LAKE PONTCHARTRAIN, L.A.
AND VICINITY
**LAKE PONTCHARTRAIN
HIGH LEVEL PLAN**

**DESIGN MEMORANDUM NO. 20
GENERAL DESIGN**

**ORLEANS PARISH
JEFFERSON PARISH
17th. St. Outfall Canal
(Metairie Relief)**

CELMV-ED-PG (CELMN-ED-SP/15 May 90) (1105-2-10c) 3d End
Mr. Eckenrod/ts/5925
SUBJECT: Lake Pontchartrain, Louisiana and Vicinity, High Level Plan, Design
Memorandum No. 20 - General Design, 17th Street Outfall Canal

ENCL 32

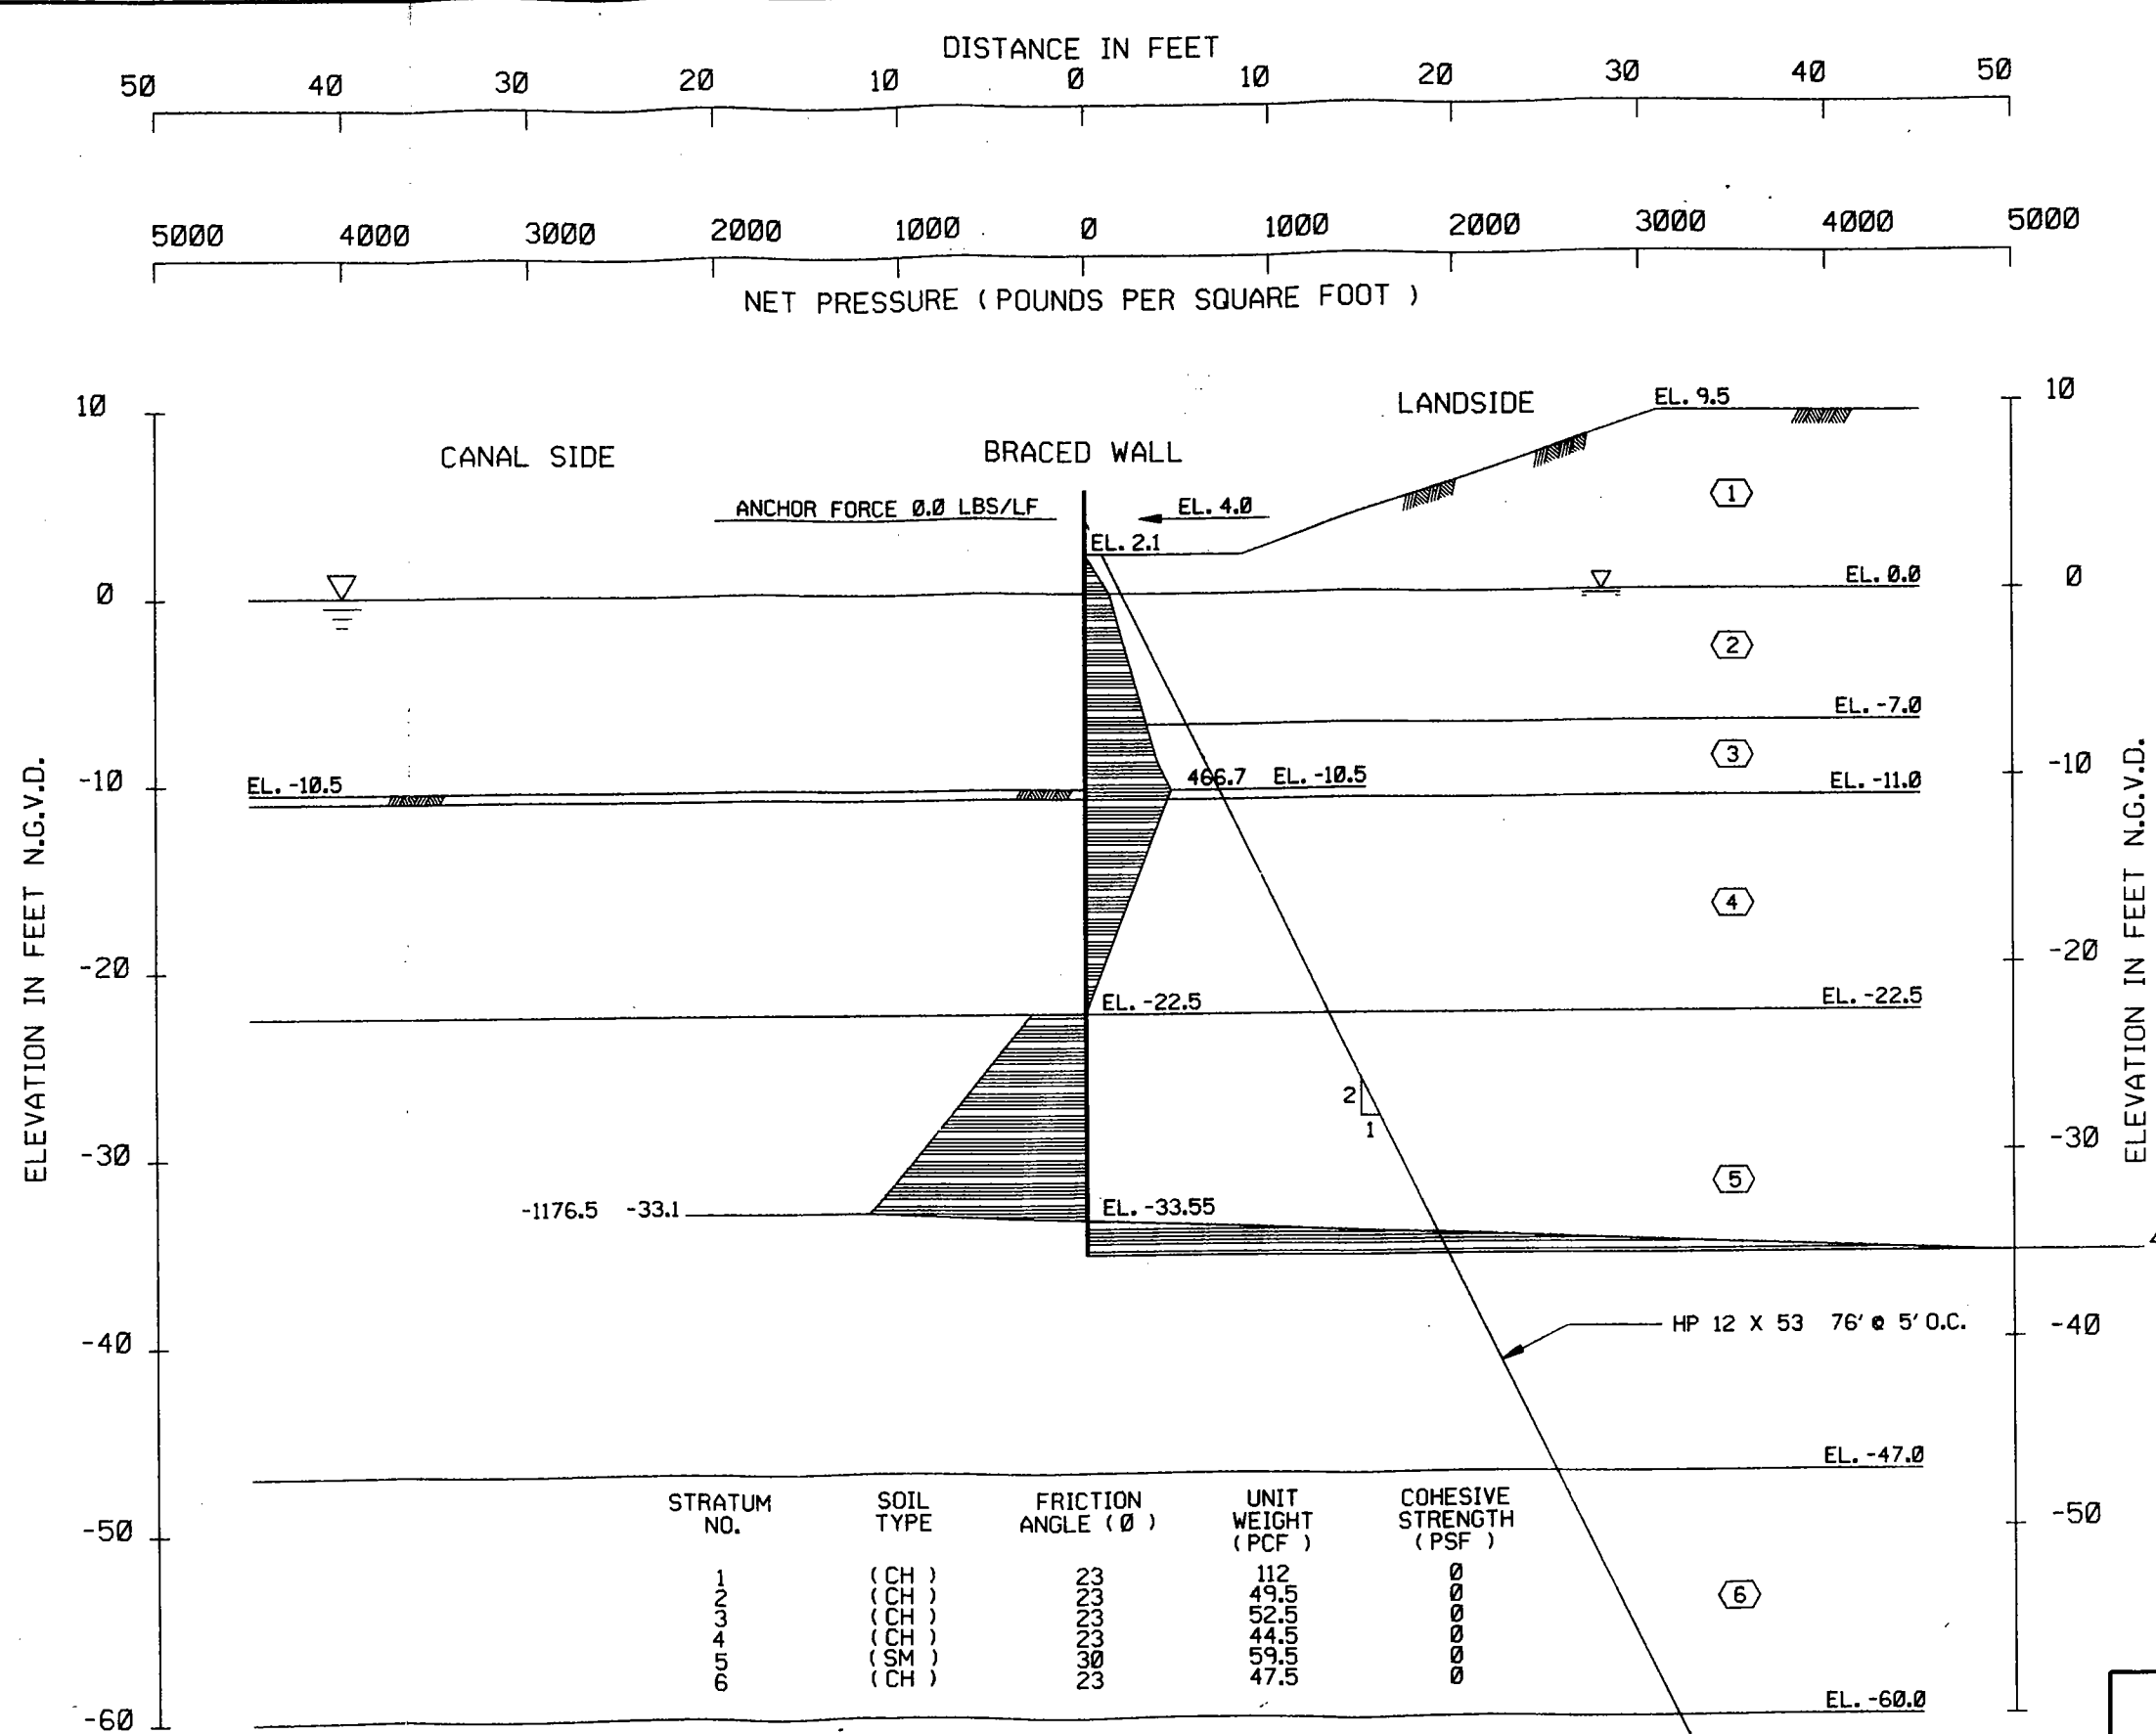
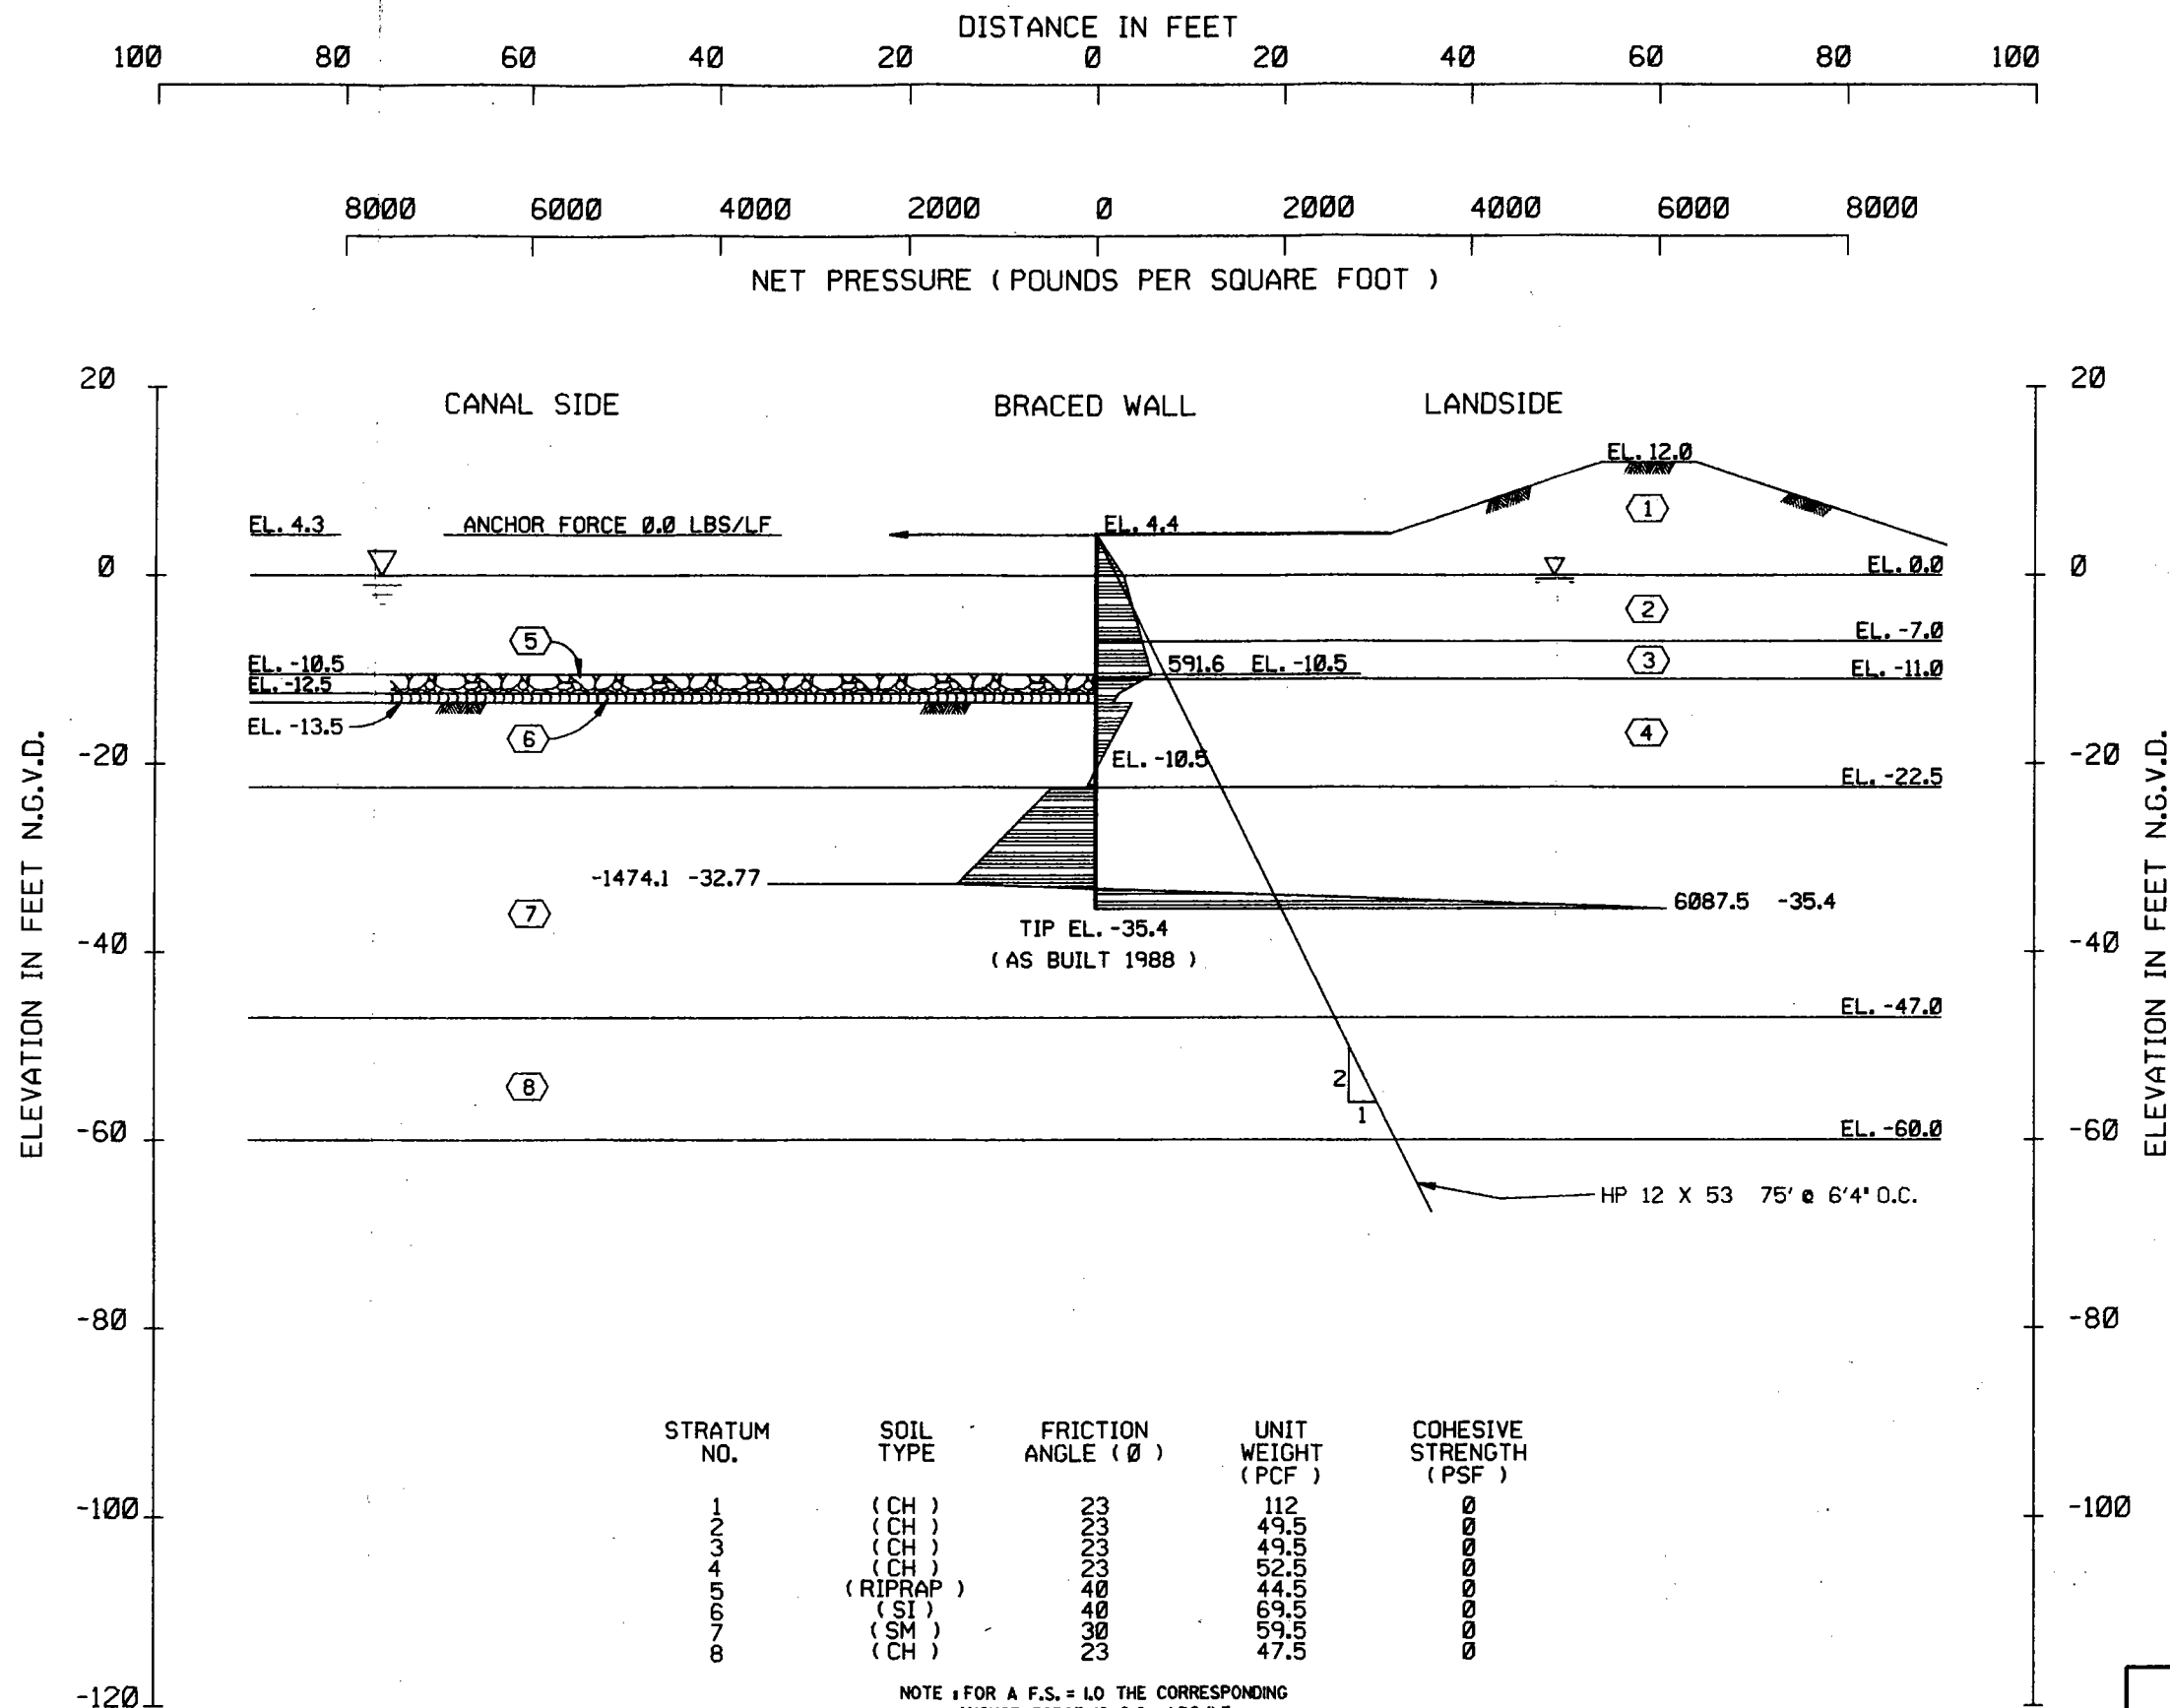
d. Para 29c. Also refer to the tied back and braced wall analyses on Plates 121-124. These analyses are based on the "Q" case soil strengths, a canal level at el -5.0, and a factor of safety of 1.5. Since these sheet pile bulkheads permanently retain soil, they should also be analyzed using "S" soil strengths, a factor of safety of 1.5, and at the normal canal level of el 0.0.

m. Plates 121 through 124. The walls shown on these plates should be evaluated for the anchor forces and resulting stresses on the anchors and the sheet piling should be checked using the conditions shown except change the water level on the canal side to el 0.0 NGVD and use soil properties for the 'S' case and a F.S. = 1.5.

d. Comment d. Para. 29c. The analyses presented were for the Q-CASE soil strengths, a canal level at EL. -5.0 and a factor of safety of 1.5. For plates 121, 122, and 124 the actual design (completed before Dec 87) was controlled by the S-CASE, F.S. = 1.5, and canal level at EL -5.0. The design on plate 123 (completed after Dec 87) was based on the S-CASE F.S. = 1.2 with canal level at EL -5.0; S-CASE F.S. = 1.5 with canal level at EL 0.0; or the 3:1 penetration to head ratio. All the braced walls and tieback walls have been constructed. The tip penetrations shown on plates 122-124 are deeper than the minimum required tip penetration (Encl 3). Intermediate tip penetrations were used to reduce the anchor forces.

m. Comment m. Plates 121 through 124. Concur. Revised plates 121 through 124 are enclosed as Encl 3.
